ADDENDUM 9

Miami Lakes Library Branch

EXTERIOR IMPROVEMENTS AND COMPREHENSIVE INTERIOR RENOVATIONS

14-JUL-2025

SHEET NUMBER
D102
OF 2

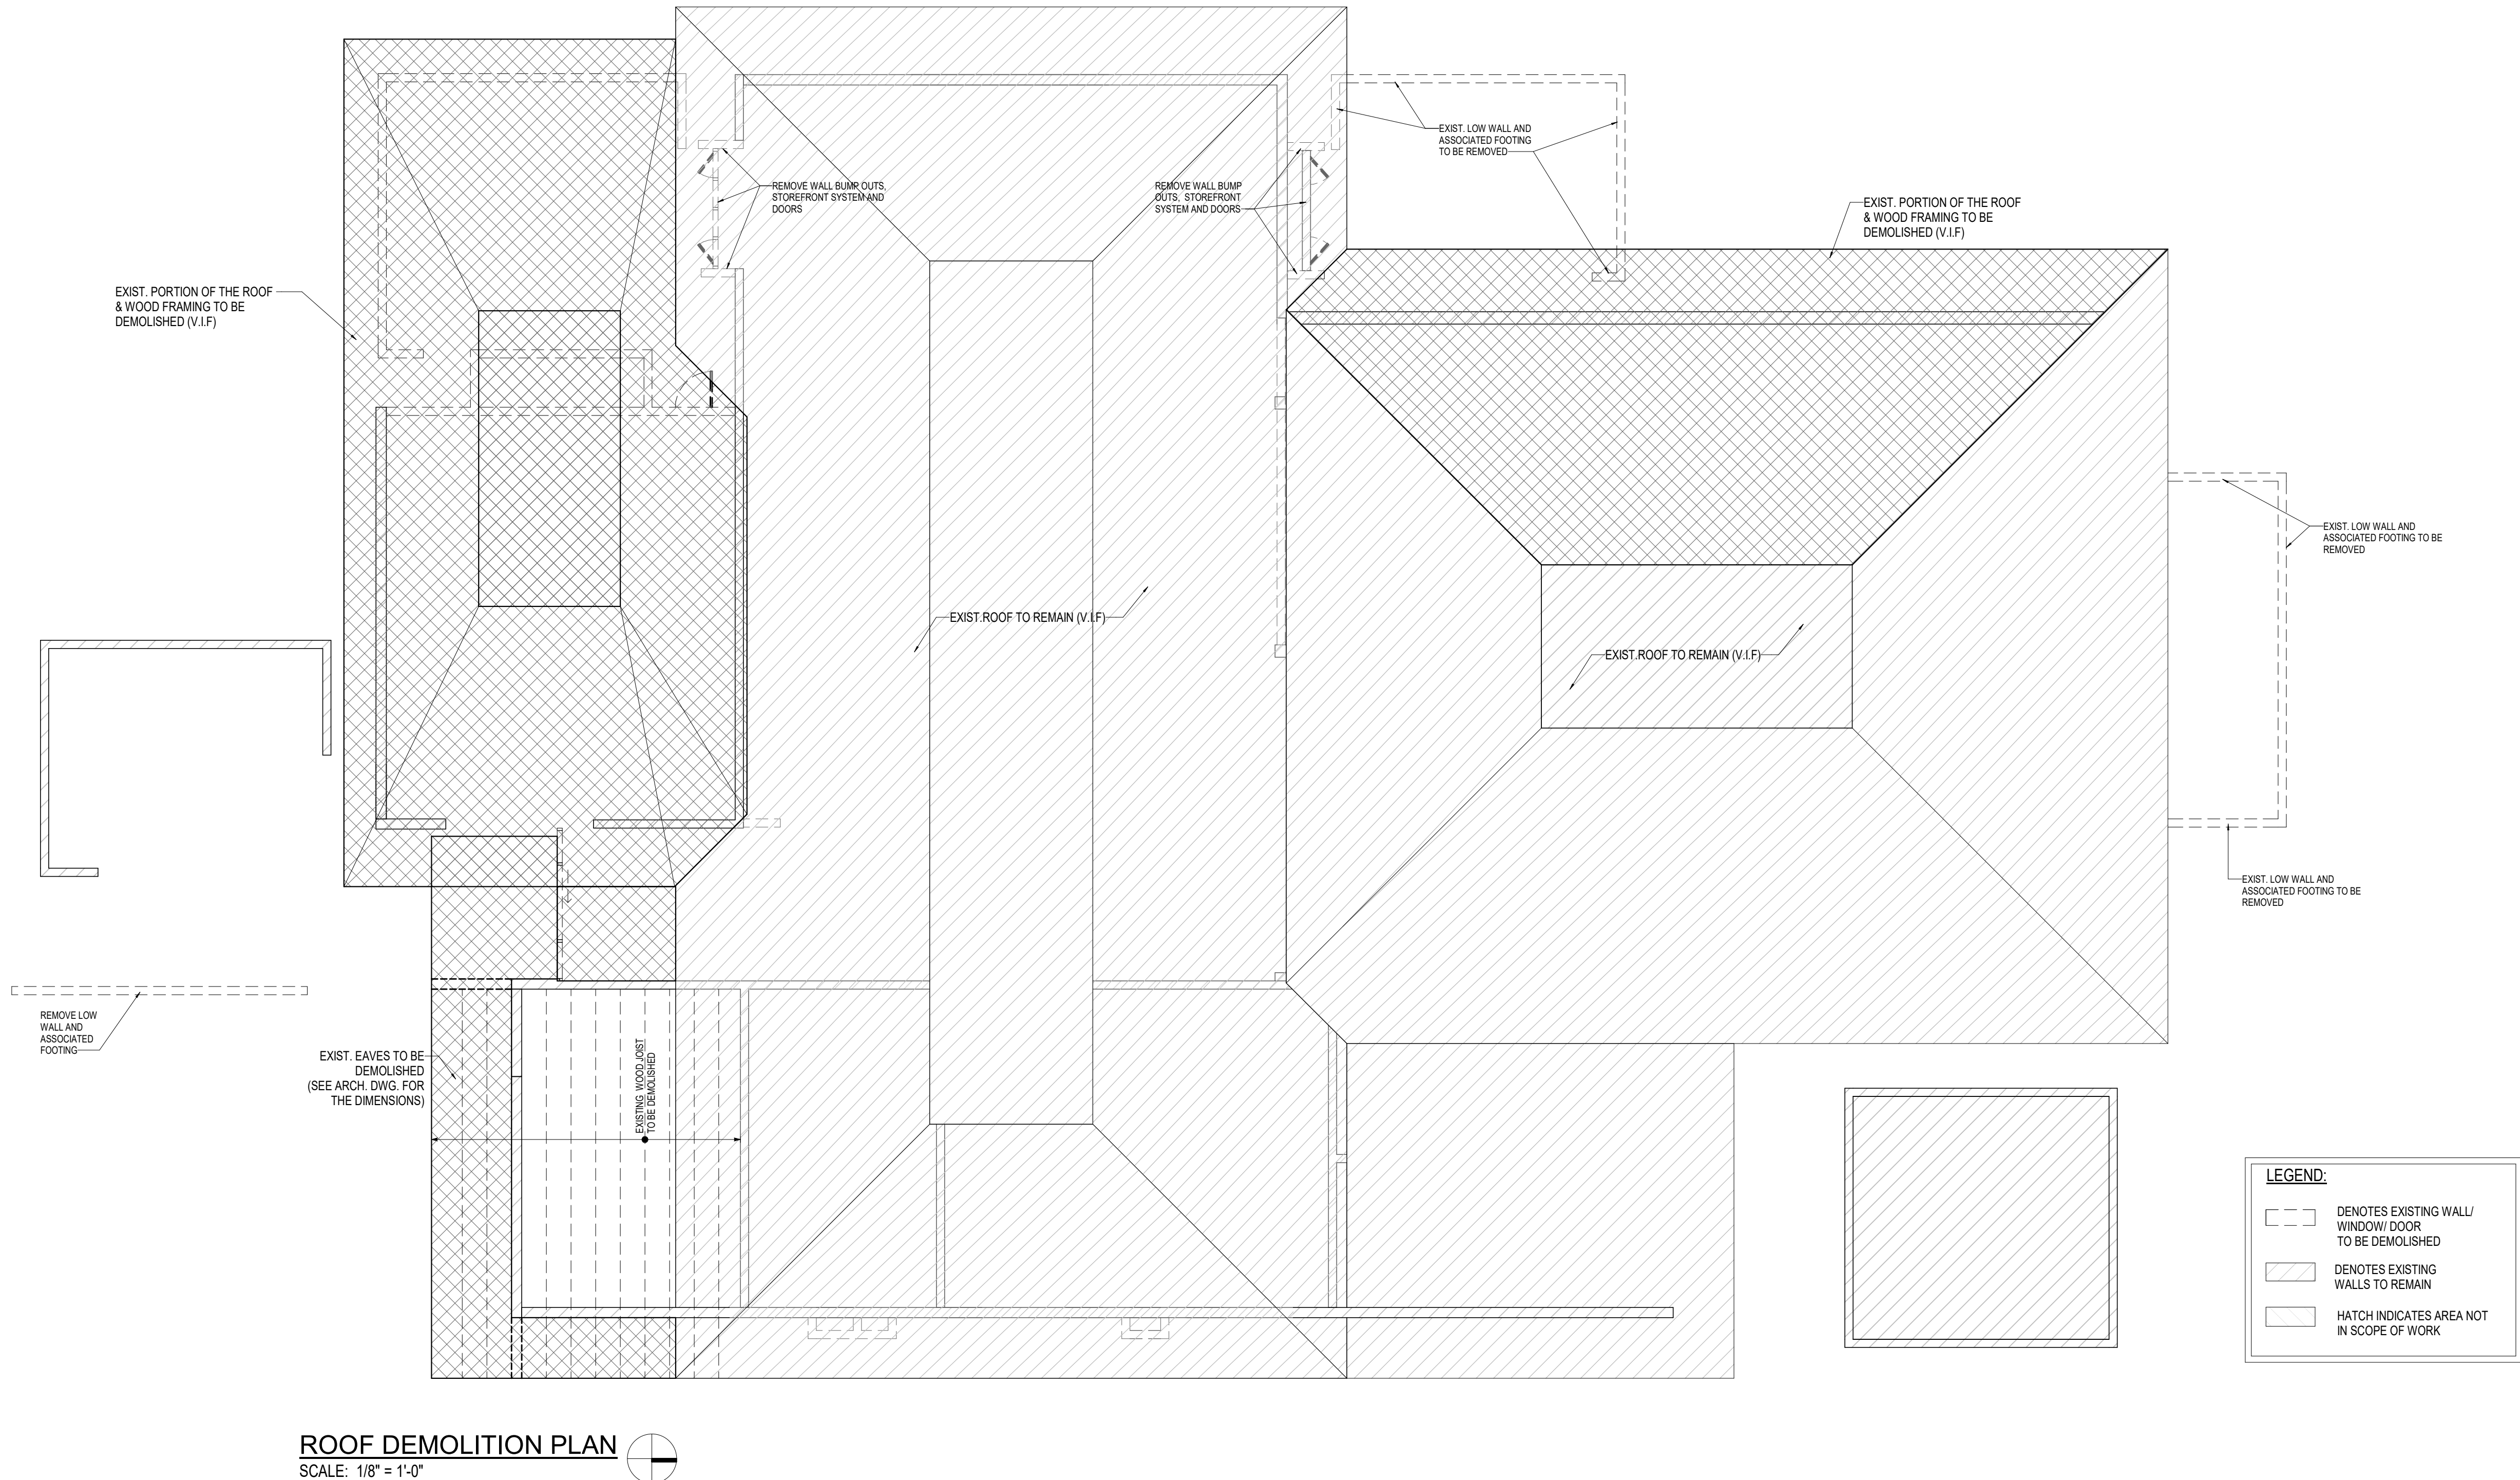
Q186. Plan Sheet D101 does not show the demolition of the roof truss areas above the entry foyer and the existing multipurpose rooms. Please add notes on structural roof demolition areas required.

A186. Please review revised drawing D102

TITLE: ROOF FRAMING PLAN

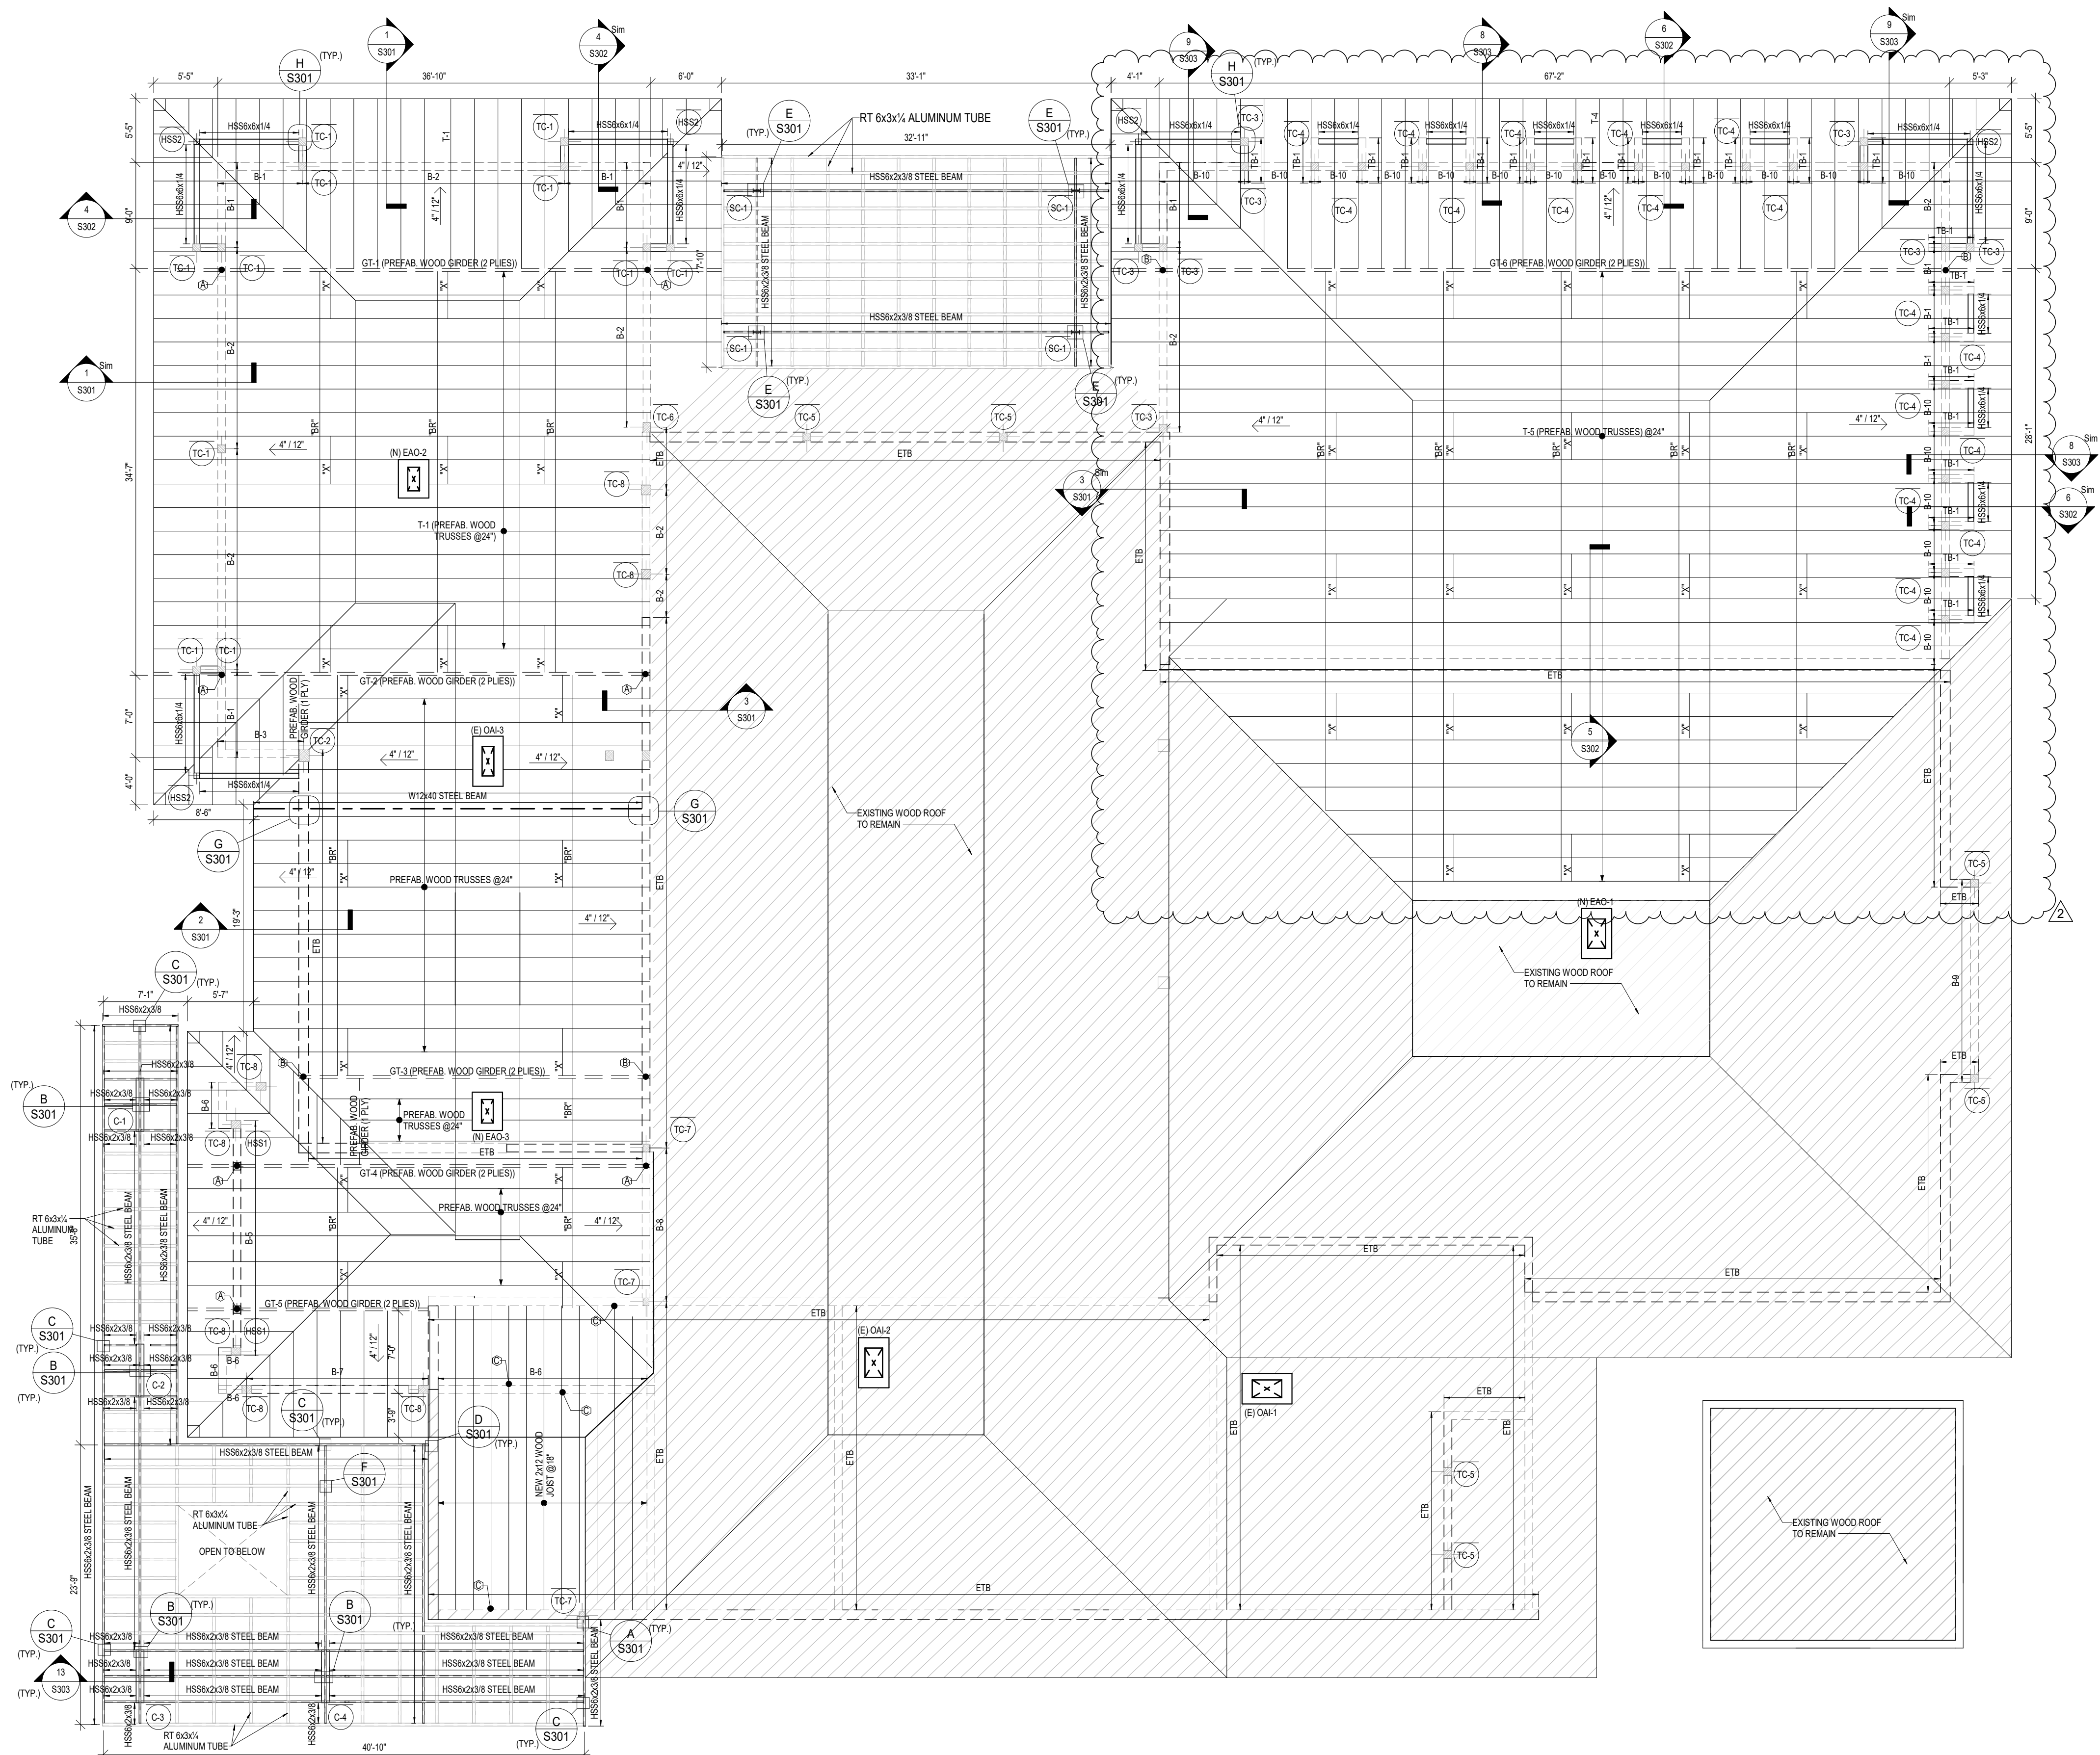
Q189. Plan Sheet S102 for Roof trusses are missing a large area of Piggy-Back trusses required above the existing roof areas at the north addition area. See Plan A3.0 showing the correct shaded area for the new trusses. Please add missing truss area to structural roof plan.

A189. Please review revised design drawing S102
